Elettra Avenue, Waterloooville

Technical Note

*Summary Transport Response and Update to HCC
Consultation Response 14/6/22 (Application No.
APP/21/00399)*

JOB TITLE		CLIENT	
WATERLOOVILLE		HARGREAVES	
DRAWING TITLE			
INTERNAL ACCESS ARRANGEMENTS			
SCALE	DRAWN BY	DATE	DRAWING No
1: 250@A1	RM	31/08/22	19235-08-GA
			REVISION
			P

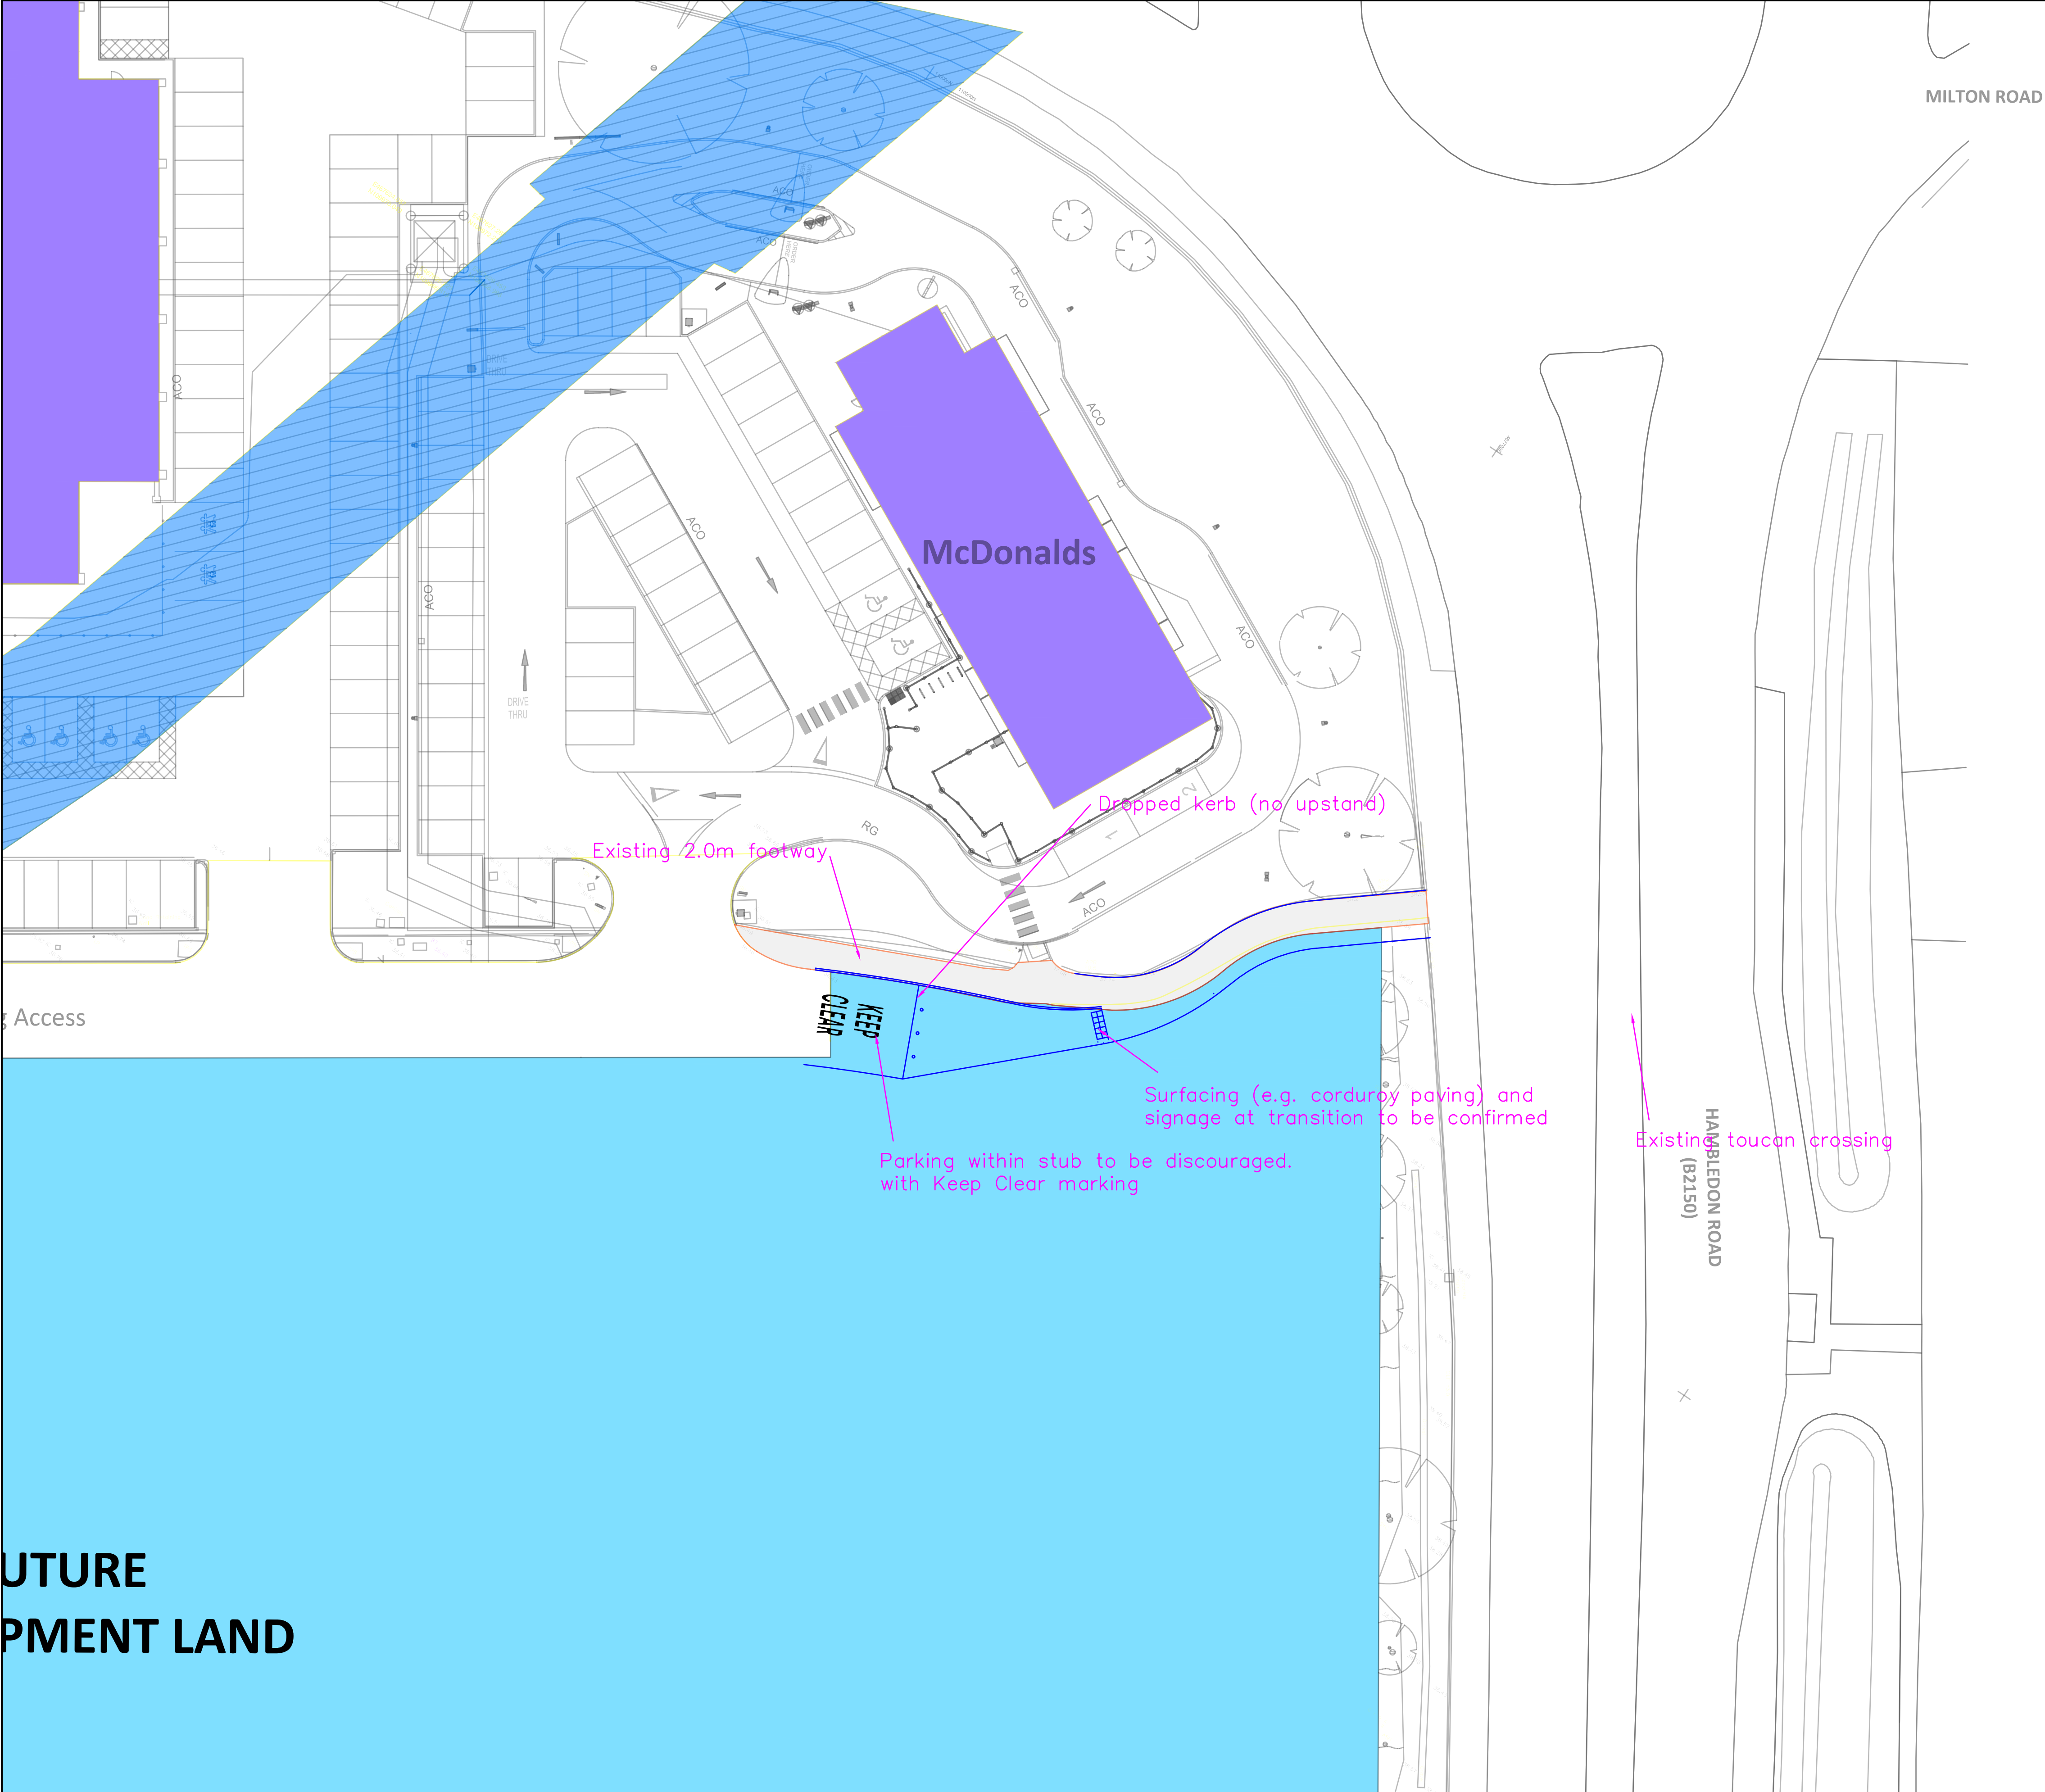
8. HCC had previously sought an improved cycle route into the site at the main vehicular access from Elettra Avenue. An enhanced design was included within **DTA report no. 19235-17** which was acknowledged as an improvement by HCC. However, further enhancement improving connectivity with subsequent development phases within the outline consent, was required by HCC. Helpful descriptive options were put forward by HCC for consideration.

12. During discussion on the above footway / cycleway, HCC requested further consideration be given to the pedestrian routing towards Unit C. Revised details setting an internal pedestrian crossing beyond the end of the Unit C Drive-Thru Order Waiting Bays is now included (as opposed to being in between stationary cars in the waiting bay).
13. An updated set of vehicle tracking drawings relevant to the car park access junction has been included at DTA Drawing **19235-08P-TRK-2** to reflect the design amendments.
14. The final matter raised in the HCC letter was the requirement for the adopted highway boundary to be overlaid on the site layout. HCC required that none of the proposed

site landscaping features sat within the adopted highway. This exercise gave rise to the need for minor amendments to the landscaping plan, with no planting included within the highway boundary; and minor tweaks to design amendments where hardstanding corners (one parking space and the Unit B drive thru exit lane) were also set back behind the highway boundary. The highway boundary is included on **DTA Drawing 19235-08P-GA** with the finalised layout.

Whilst the scheme represents a betterment over what was shown originally, the Highway Authority are concerned that the proposed scheme does not present a continuous and cohesive approach for cyclists to access this parcel of the development and the wider development area when approaching from the north. During discussions on the outline planning application, the Highway Authority agreed to review the proposed pedestrian and cycle access strategy at the full application and reserved matters stage given that the applicant was unable to commit to a pedestrian and cycle access strategy until points of access and servicing requirements were better understood. This agreement was on the basis that a holistic strategy would be developed which served the whole site, or that the infrastructure which came forward as part of separate parcels of the development would not preclude future sustainable transport users from accessing the rest of the development.

This concern could be overcome by extending the new section of shared use path available on the western side of the road past the site access, terminating at a point to the south of the site for the rest of the outline development area to connect into in the future. In order to provide this widening, the southern Elettra Avenue approach to the roundabout would need to be reduced to one lane, unless internal amendments can be provided to allow for additional width along the path. This would ensure a continuous route is available for cyclists to the site as a whole, rather than providing a limited section of shared use path which cannot be extended in the future given the land constraints of the site. Updated junction modelling would be required to demonstrate that a one lane entry into the roundabout works in operational capacity terms. This approach adheres to HCC's emerging LTP4 policy which looks to prioritise pedestrian and cycle movements over vehicular capacity.

By providing a link through to the existing pedestrian crossing point south of the site access, cyclists could be signed to enter the site through this link, tying into the cycle parking facilities available outside of the proposed food store. It is noted that accessibility to the cycle parking to the drive thru's is poor and does not align with the current cycle facilities. The cycle stores should therefore be relocated to tally with the revised cycle strategy for the site.

The Highway Authority have also noted that the proposed landscaping features around the north-western corner of the site is located very close to the edge of the highway boundary. The applicant is required to overlay the highway boundary on the site layout plan to confirm that highway land is not required to provide any of the features around this part of the development. The Highway Authority would not support the stopping up of highway land for the benefit of amenity landscaping to the development. This should be within land outside of the adopted highway. The Highway Authority therefore also require confirmation that the area is not included within the landscaping requirements for the site and will remain public highway.

9. This led to further amendments with the content now agreed with HCC. The design is shown on **DTA Drawing 19235-08P-GA**. This includes an off carriageway 3m shared footway / cycleway along the western side of the Waterloo Park access road off the roundabout, with cyclists provided safe crossing on the site access arm of the roundabout. This will safeguard access by active travel modes to the remaining areas covered by the original outline consent and has been achieved with a modest narrowing of the northbound carriageway on the approach to the roundabout; and narrowing of the verge between the access road and the car park to the south of the car park access. The 3m width is extended northwards through to the new western pedestrian crossing of the Elettra Avenue roundabout which links to the footway on the western side of Waterberry Drive.

10. This 3m facility provides off-carriageway linkage to a pedestrian route away from the vehicular access through the Unit A car park, with cyclists directed to this route, only dismounting on their entry to the car park.
11. Confirmation was sought that the footway / cycleway alignment would not have a detrimental impact on traffic capacity at the Elettra Avenue site access roundabout. Whilst the carriageway narrowing from the previously appraisal was extremely modest, for the purposes of a straightforward robust assessment, the site arm exit onto the roundabout has been modelled in JUNCTIONS10 as a single lane, which demonstrates significant spare capacity as shown below, with the output provided at **Appendix B**. In practice, the arm benefits from a flare, increasing capacity further.

- Further off-site pedestrian / cyclist enhancement works are provided within public highway in the form of a new short section of footway / cycleway at the junction of Waterberry Drive / Elettra Avenue and associated crossing detailing. These works are shown on **DTA Drawing 19235-08P-GA**.

JOB TITLE		CLIENT	
WATERLOOVILLE		HARGREAVES	
DRAWING TITLE			
INTERIM PEDESTRIAN/CYCLE LINK			
SCALE	DRAWN BY	DATE	DRAWING No
1: 250@A1	RM	26/09/22	19235-08-GA3
			REVISION
			P

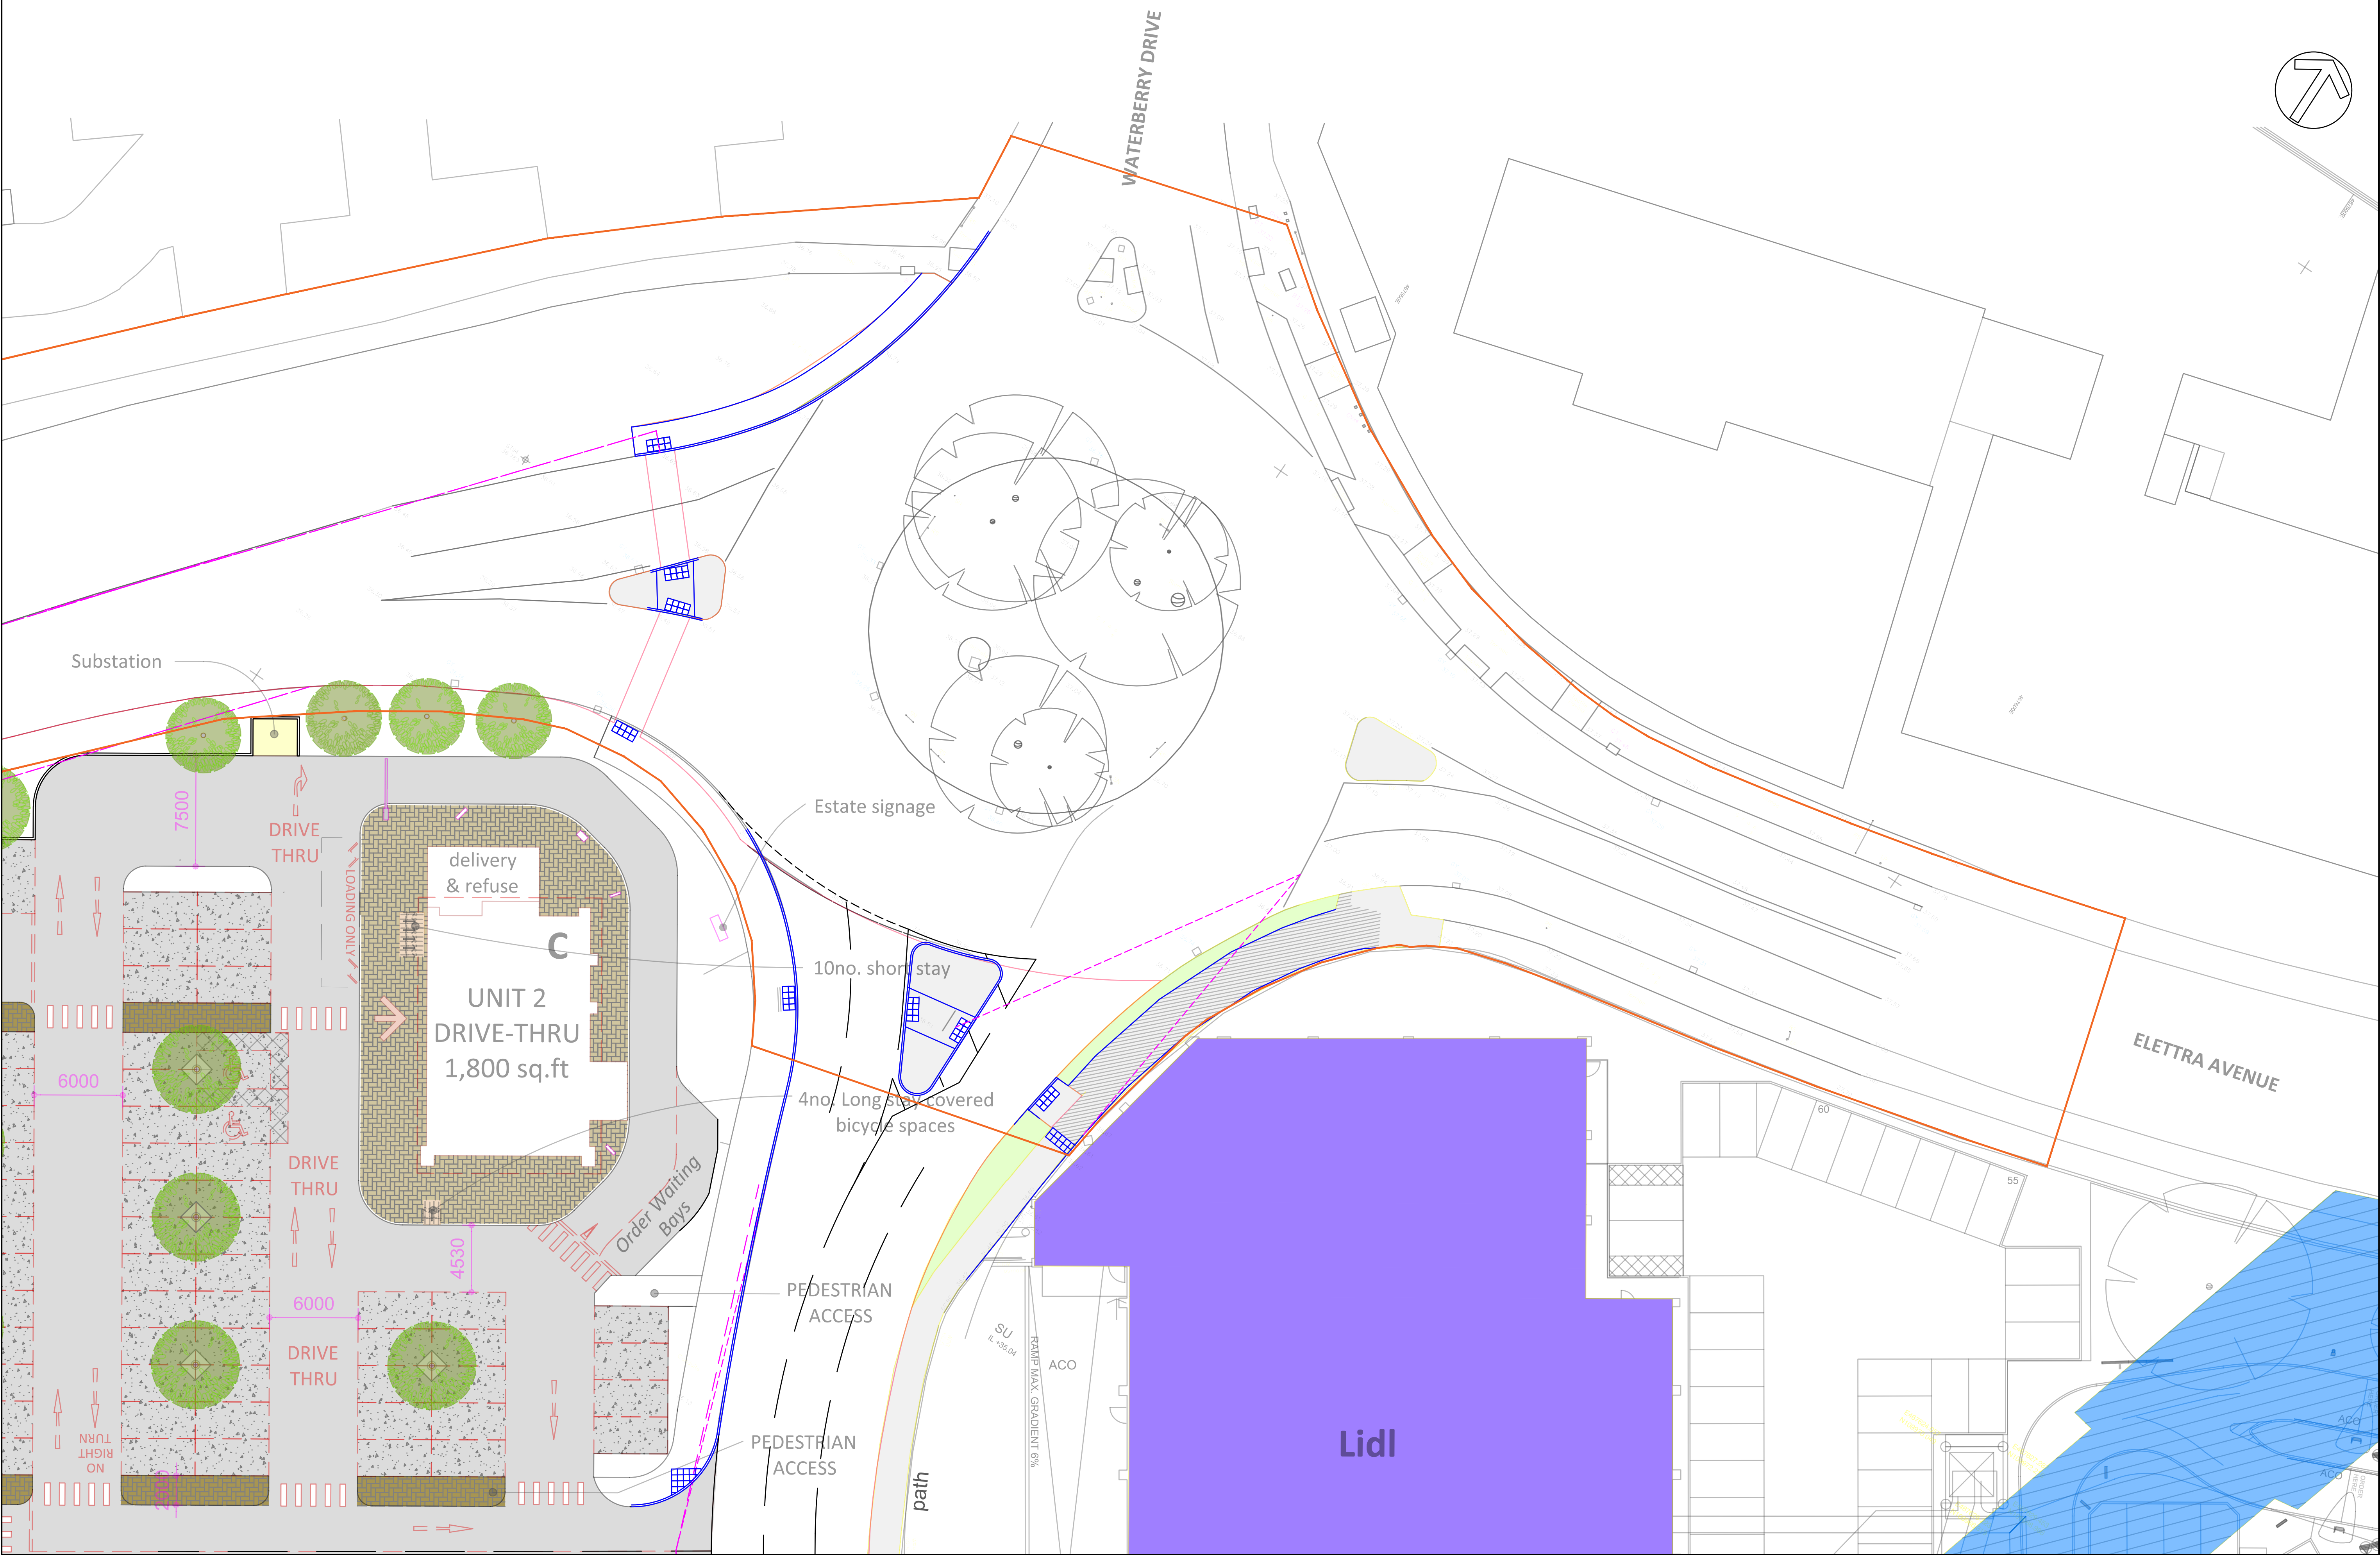
As recommended within the Highway Authority's previous response, the applicant has updated the design for the proposed shared use widening scheme to the south of the McDonalds store. The improvement incorporates flaring on the approach to the carriageway to provide cyclists with a wider area to access the path in the event that a vehicle is parked in the current turning head. The flaring is supplemented by 'keep clear' markings to discourage parking and allow cyclists to safely access and egress the path. The scheme has been reviewed by the safety auditor who has not raised any concerns with the proposal. Whilst consideration will need to be given at detailed design to segregating the levels between the two paths, the Highway Authority are satisfied with the principle of the updated scheme which should be secured via obligation in the Section 106 agreement to be delivered via S278 by the applicant.

6. The concept of widening of the footway to the south of the McDonalds store to provide a footway / cycleway facility has long been agreed. Further design revisions have been prepared and agreed for planning as shown on **DTA Drawing 19235-08P-GA3**.

7. Prior to implementation, the design will be subject to detailed design with the potential for slight grading segregation between the footway and cycleway elements. This detail would be secured via planning condition with the works delivered by the applicant. As the land is not public highway, but forms part of the wider Waterloo Park land, it may be necessary to agree some standard wording in the S106 agreement to ensure that the public is afforded rights to pass through the site without prejudicing the ability to implement the remainder of the outline consent (i.e. maintain the ability to adapt the precise form when the remainder of the site is implemented).

- Whilst not within the public highway, a further cycle enhancement is provided to the south of the McDonalds outlet within Waterloo Park. The enhancement delivers cycle link connectivity to Hambledon Road. These works adapting a footway to a footway/cycleway are shown on **DTA Drawing 19235-08P-GA3**.
